SERIOTA SITE PLAN
Project No. 2015-28

SITE PLAN

**TOWN OF NEWBURGH
PLANNING BOARD
TECHNICAL REVIEW COMMENTS**

PROJECT NAME: SIEROTA SITE PLAN
PROJECT NO.: 15-28
PROJECT LOCATION: SECTION 94, BLOCK 1, LOT 61 & 57
REVIEW DATE: 13 NOVEMBER 2015
MEETING DATE: 19 NOVEMBER 2015
REPRESENTATIVE: ENGINEERING & SURVEYING PROPERTIES

C-1

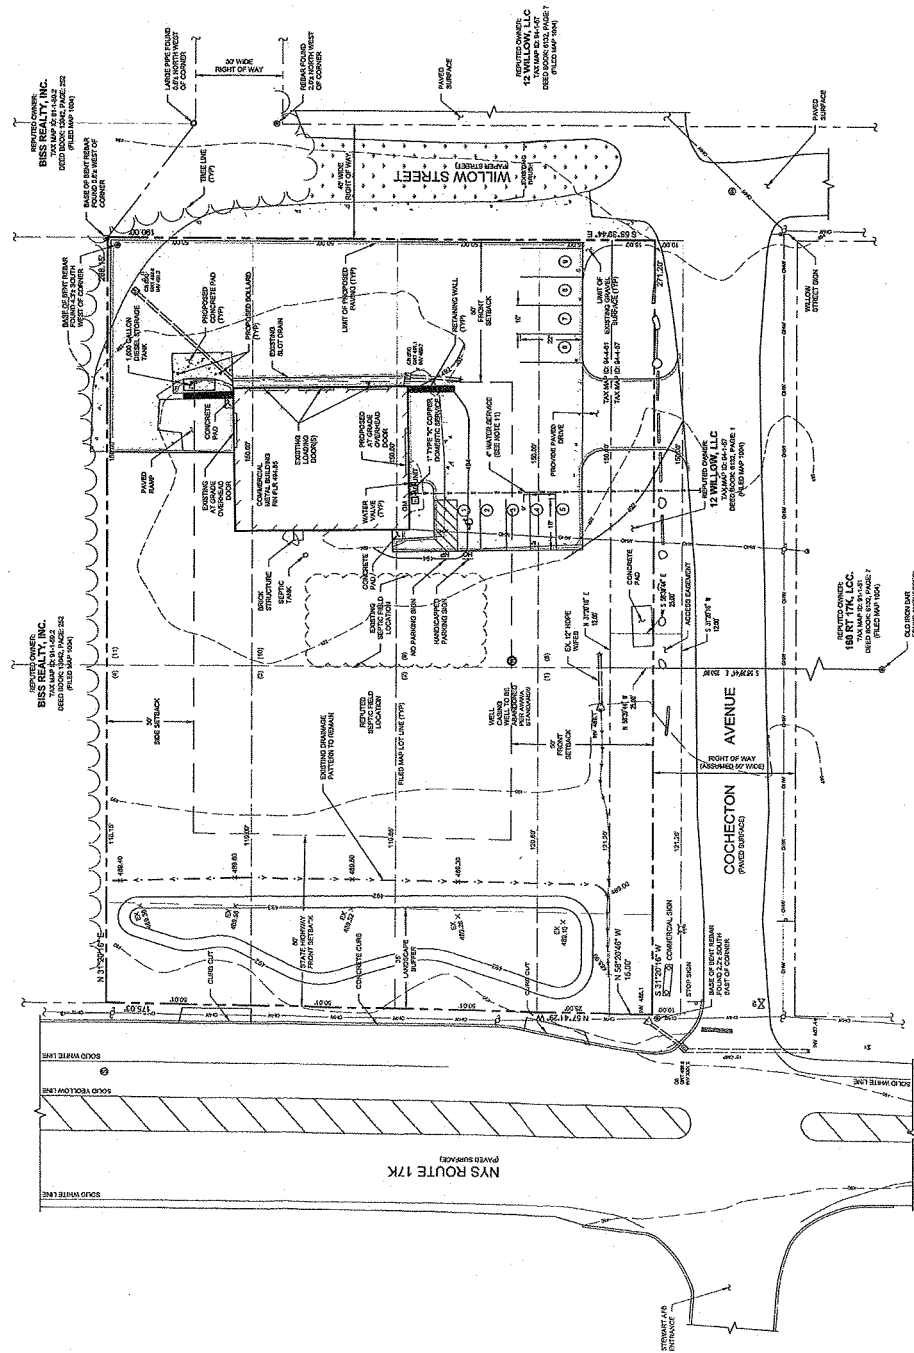
1. The Applicant's representative was requested to clarify tax map 57 to be combined with tax map 61. Portions of tax map 57 appear to extend to the north side of Willow Street only a portion of lot 57 is proposed to be combined with lot 61. In addition filed map lines are identified on the parcel which should be addressed during the consolidation.

2. The Applicant's have identified they are going to request a waiver for the sprinkler system.
3. The Applicant's have identified they intend on paving the gravel areas of the site. The Planning Board should address the need for curbing on the site.

7. Note 9 should be revised that vehicles for repair is limited to 4. Currently it states the maximum vehicles of 4 onsite designated parking spots. In addition, Note 9 seems to conflict with the Note 7a which identifies 3 vehicles.

8. County Planning referral is required.
9. A 490 contour is required between the proposed berm on Route 17K and the swale depicted on

the plans.

10. If project is identified as being exempt from curbing we would recommend some means of controlling placement of vehicles on the site. Possibly a split rail fence, bollards or some other method to contain vehicles to the proposed paved surfaces.
11. Size of all proposed landscape plants must be identified.
12. Provisions for a dumpster must be included. Used tire storage, cardboard and other waste typically generated must be addressed.
13. The landscape buffer should include a stonewall typical to other developments along the highway corridor.

1. Lot 57 is also part of the purchase and is controlled by the same owners. Lot 57 has been added to the plan as part of the application and note #10 has been added stating that the lots shall be combined into a single lot with a single owner prior to signing of any approved maps.

5. Please find the landscape plans by others in the attached plan sets.
6. The 1,000-gallon tank is proposed. Its location has been moved away from the property line.

PLANTING PLAN
 SHEET NO. L-1

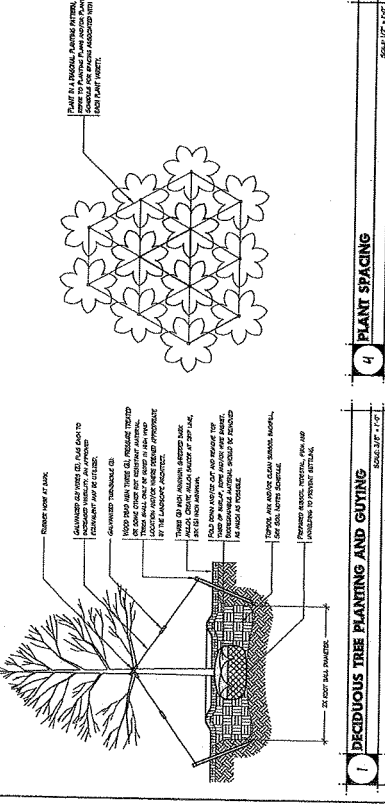
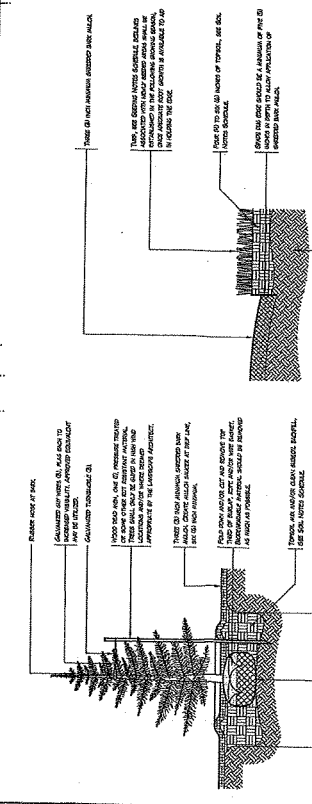
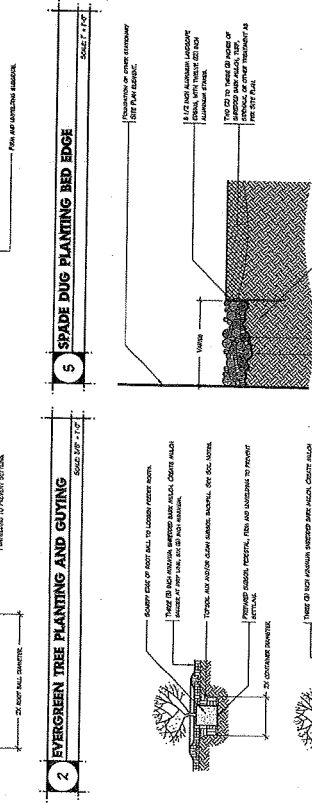
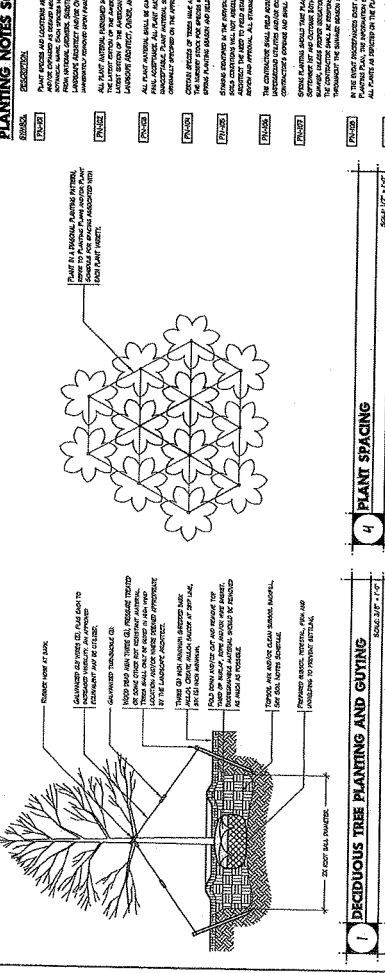
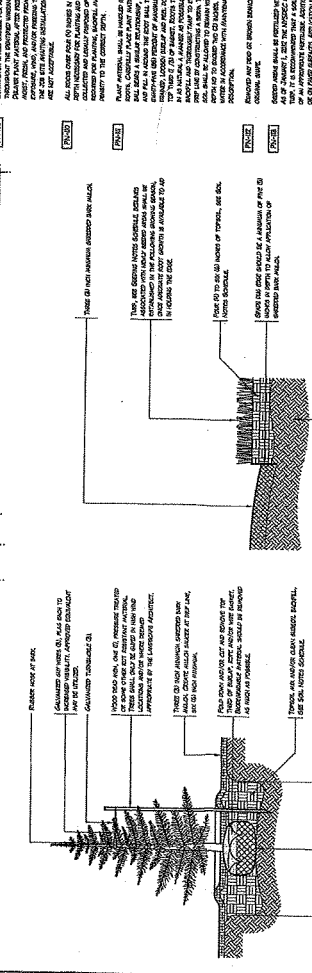
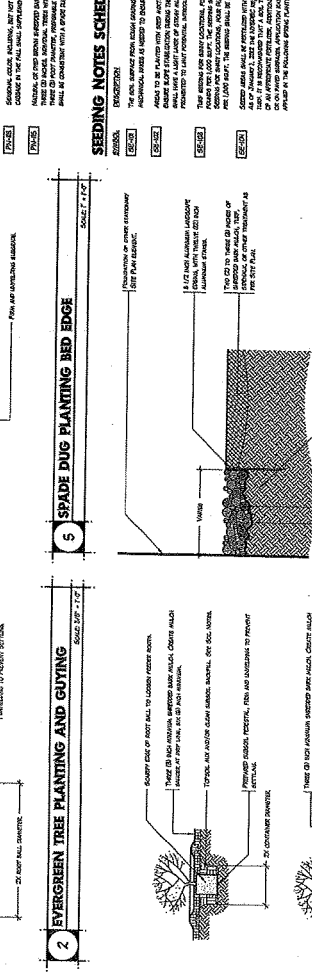
MR. HINES: The size of the landscaping plants is left off the landscaping plan. We need the size of those.
